DOCUMENT CHANGE REQUEST

DCR number 505	Changes required for: General	Originator: S Jeffery - ESCC
Date: 2009/04/28	Date sent: 2009/04/28	Organisation: ESA/ESTEC
Status: IMPLEMENTED

Title:	Transistors High Power PNP, based on type BUX78		
Number:	5204/006	Issue:	2

ESCC Detail Specification No. 5204/006

Maximum Safe Operating Area Graph

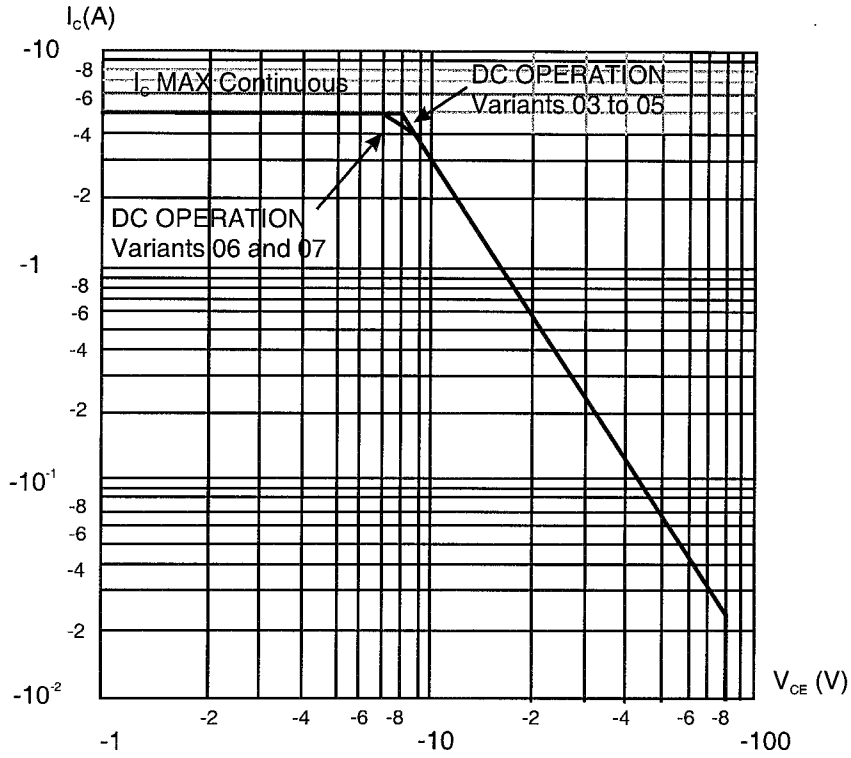
3. Safe Operating Area applies as follows:
